24 HESKETH STREET, CHAW CHASE
(HPC Case # 55/13-12 EEJ)

SUBJECT: Historic Area Work Permit #618987, rear addition and garage demolition and new construction

MONTGOMERY COUNTY HISTORIC PRESERVATION COMMISSION
STAFF REPORT

PROPOSAL: Rear addition and garage demolition and new construction

SECOND FLOOR NEW

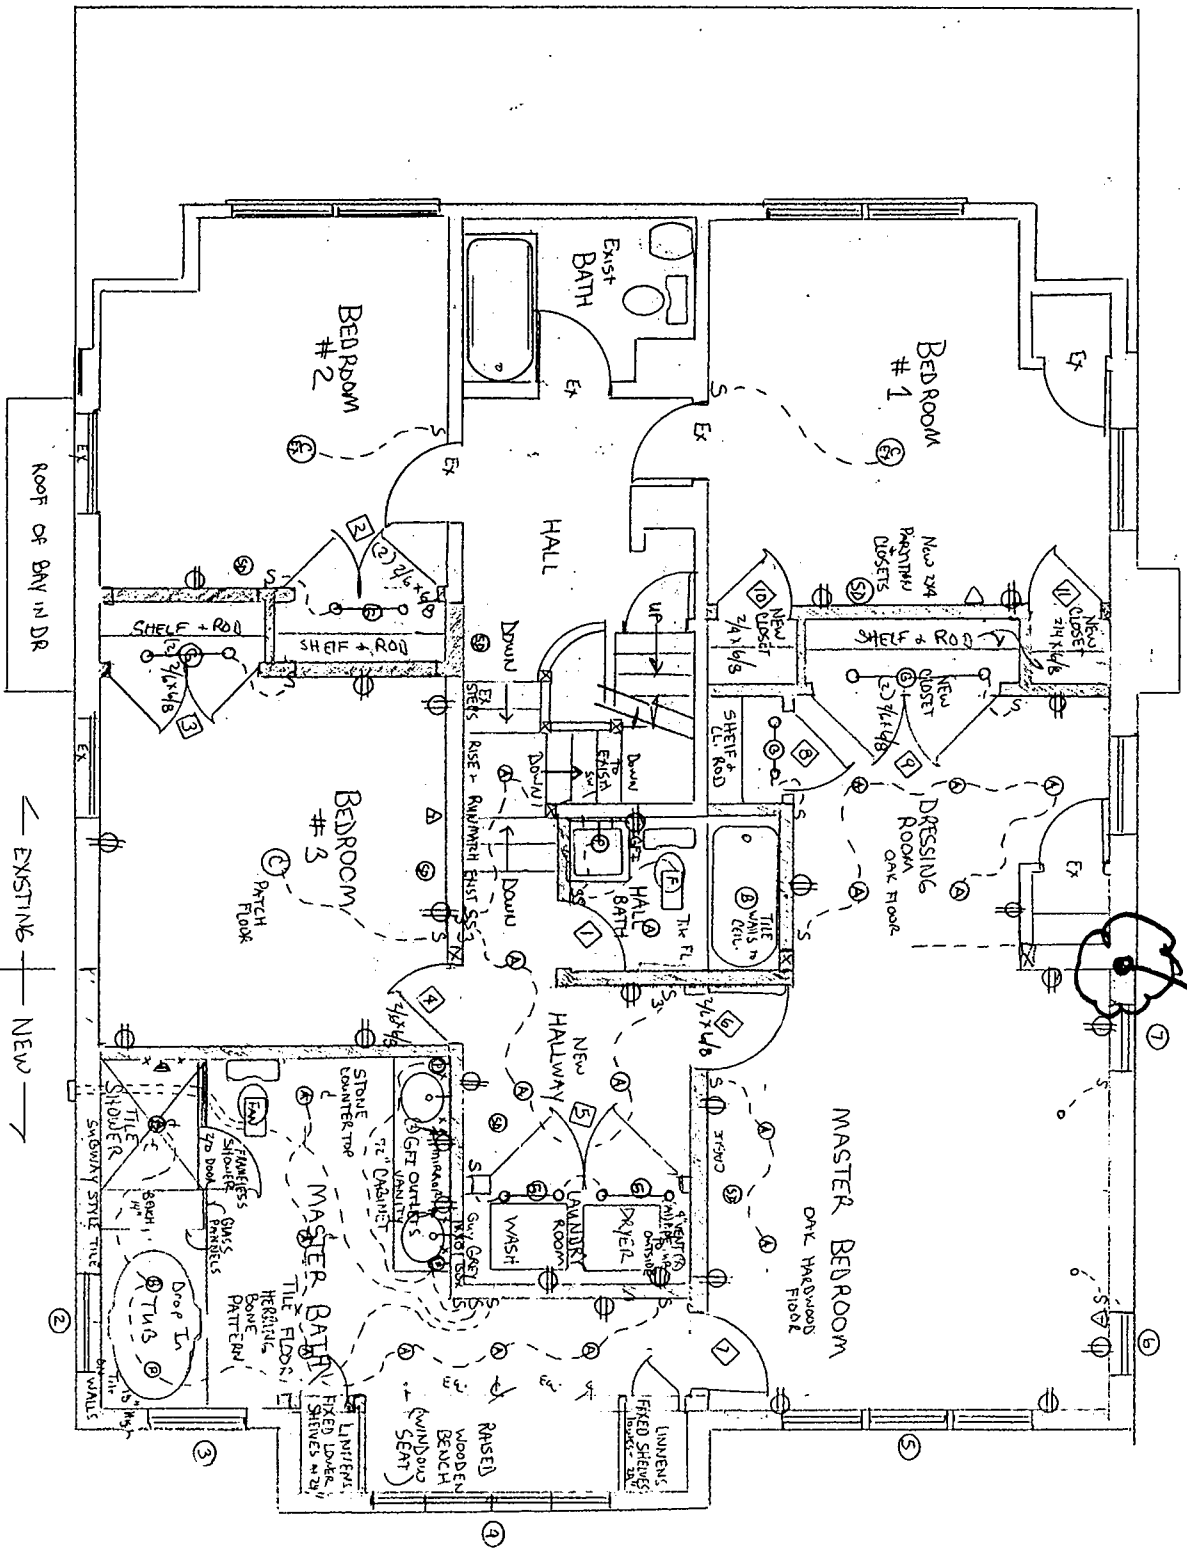
NEEDS INSERT

FIRST FLOOR PLAN EXISTING & NEW 1/4"=1'

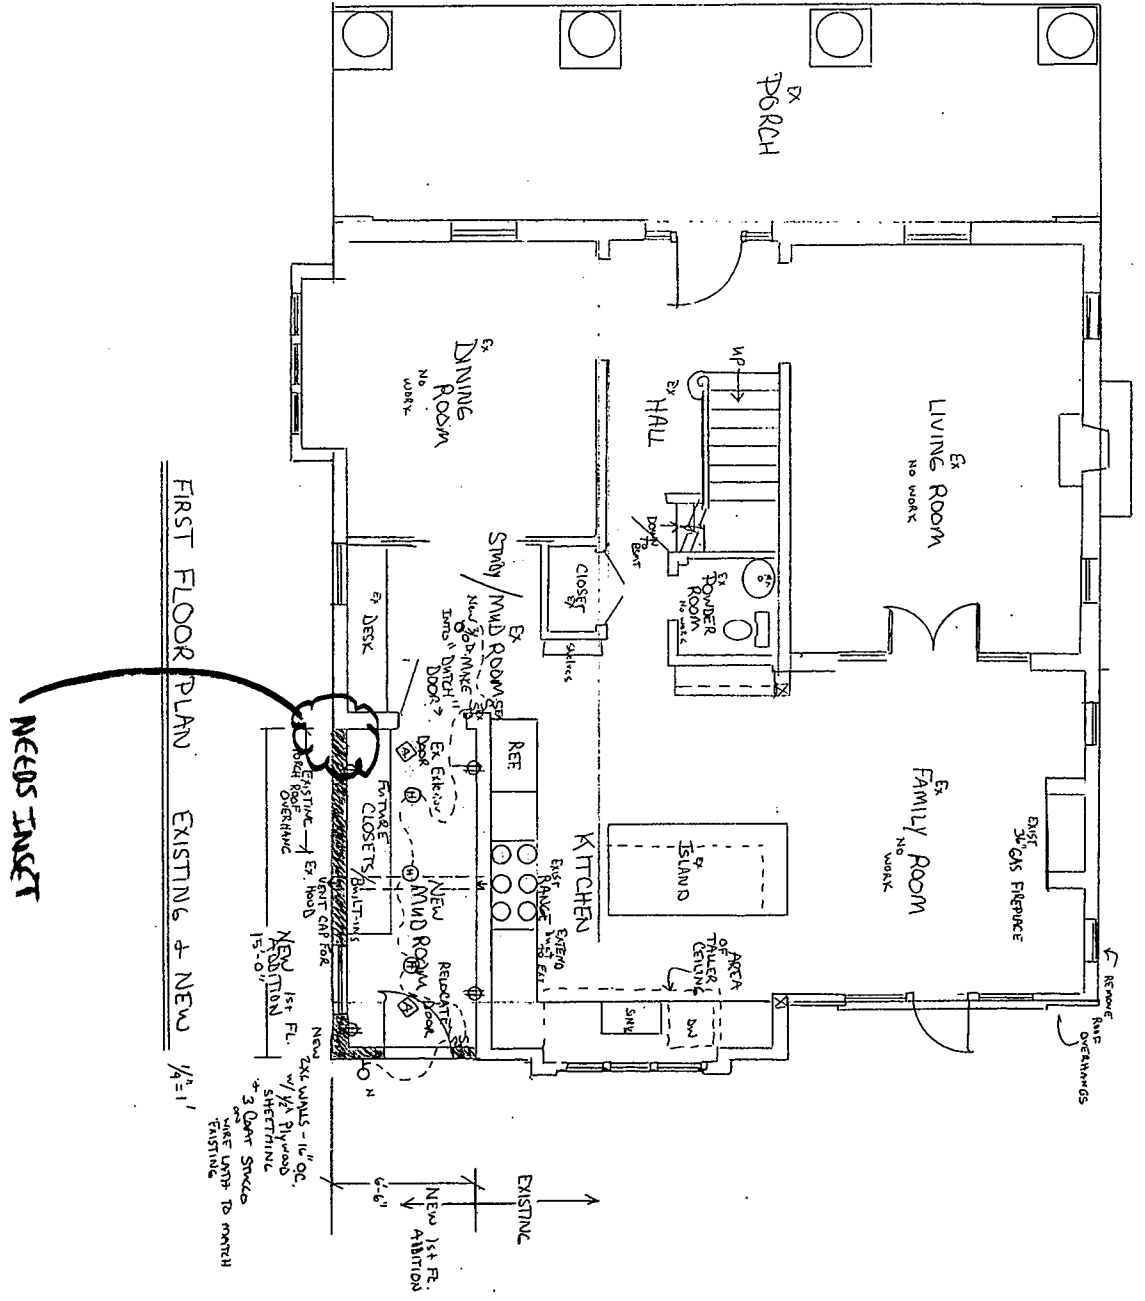
NEEDS INSET
